Rezoning Transportation Analysis

Petition Number: 2021-178

Date	Description
11/21/2021	First Review (PDM)
12/20/2021	Second Review (PDM)

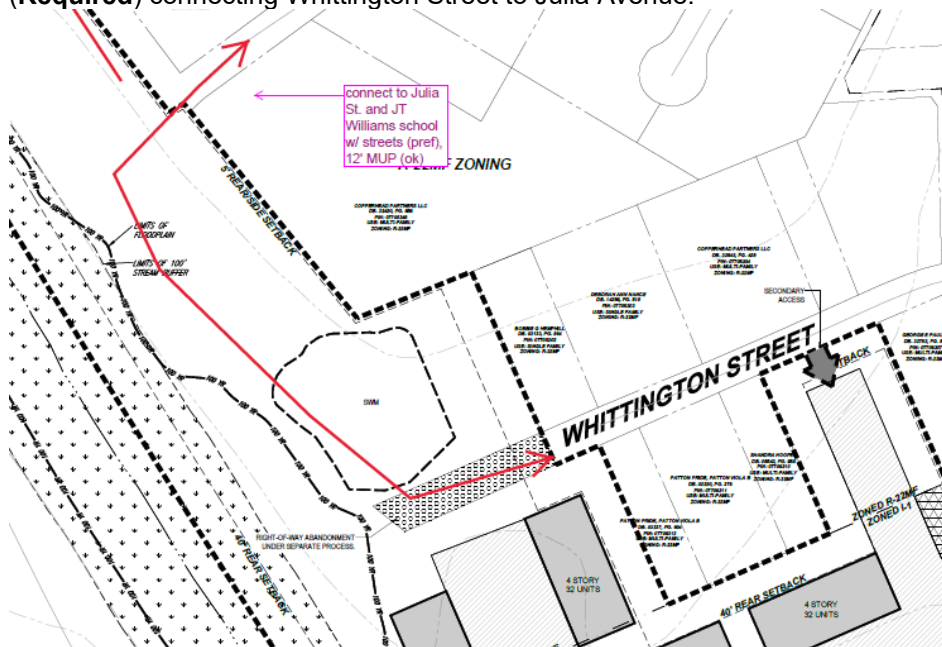
Outstanding Comments from 11-21-21: Show centerline of Statesville Avenue on site plan and dimension the proposed ROW from the centerline.
5. The proposed dwelling units exceeds 12 per acre. Per Chapter 20 Subdivision ordinance, site plan and conditional note(s) revisions are needed to commit to construct an 8-foot planting strip, and 12-foot multi-use path along Statesville Avenue and Atando Avenue. The wider sidewalk also meets the Charlotte WALKS Policy and Charlotte BIKES Policies.

Outstanding Comments from 11-21-21: Show and label the 8-foot planting strip along Stateville Avenue. Add conditional note committing to the installation of the 8-foot planting strip and 12-foot multi-use path along Statesville Ave.

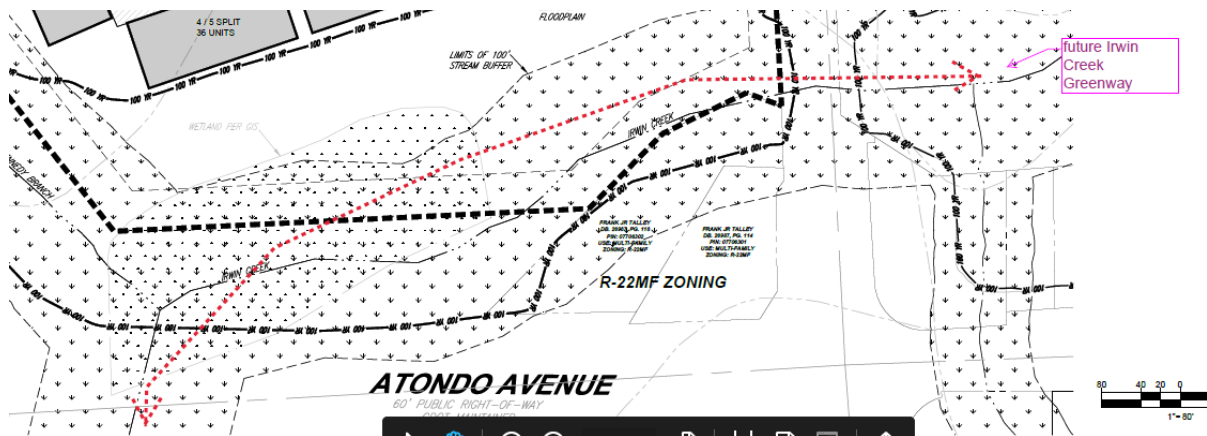
11. **Outstanding Comments from 11-21-21:** Revise site plan and conditional note(s) to commit to installing a local residential median street per CLDSM U-02 (**Request**) or a 12-foot multi-use path (**Required**) connecting Whittington Street to Julia Avenue.

12. **Outstanding Comments from 11-21-21:** Dedicate greenway easement for future Irwin Creek Greenway. Coordinate with Mecklenburg County Parks and Rec for location of easment. In addition, coordinate with County on easement dedication for greenway spur to JT Williams Montessori School from future Irwin Creek Greenway.
